Vapor Recovery Test Procedure

TP-~~201.20~~ 201.1D

**Pressure Integrity of
Drop Tube Overfill Protection Prevention Devices**

Note: The text is shown in ~~strikeout~~ to indicate text that is proposed for deletion and underline to indicate text that is proposed for addition.

Figure 4
Inflatable Bladder Installation

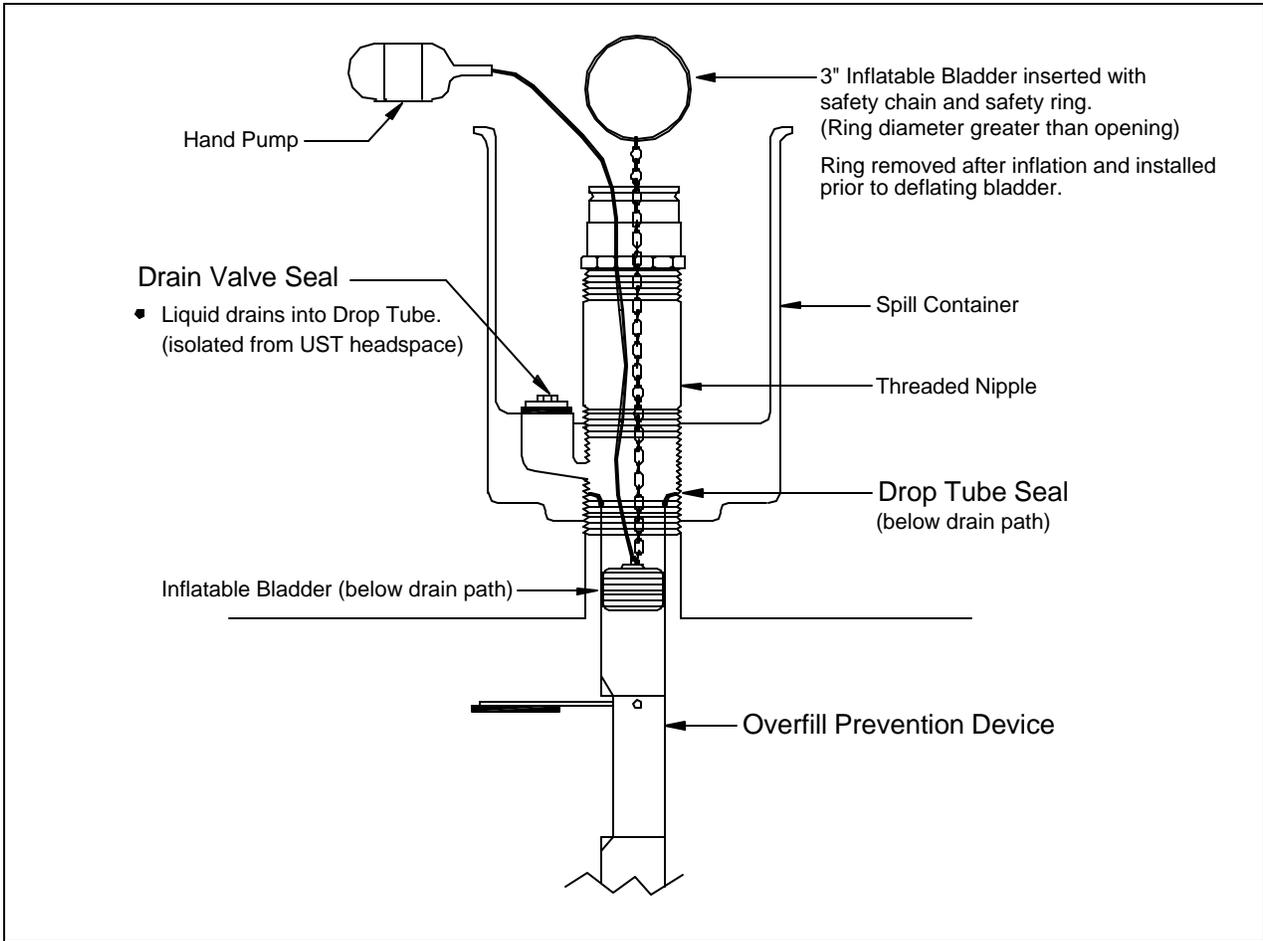
- 5.7** Inflatable Plumber' Bladder. Use a "3-4" inch diameter inflatable plumber's bladder and extension hose equipped with a safety chain, as shown in Figure 4, to isolate the drain valve from the Overfill Prevention Device when applicable. The safety ring must be removable, allowing the tester to remove the ring following inflation and attach the ring prior to deflation

6.6 Inspect the drain valve configuration. Determine whether the drain valve drains liquid directly into the drop tube above the Overfill Prevention device, as shown in Figure 4, rather than into the underground storage tank ullage space. If the drain valve drains into the drop tube, the procedure will quantify the leak rate through both the Overfill Prevention Device and the drain valve, and the maximum allowable leak rate for both devices is the sum of the two individual leak rates.

- 7.5.1 Remove the Product Test Cap from the product adaptor.
- 7.5.2 Carefully install an inflatable plumber's bladder ("3 - 4" inch model) into the drop tube as shown in Figure 4 and inflate. Once inflated, carefully remove the safety ring allowing the chain to rest on top of the bladder and reinstall the Product Test Cap. The drain valve is now isolated from the overfill prevention device.
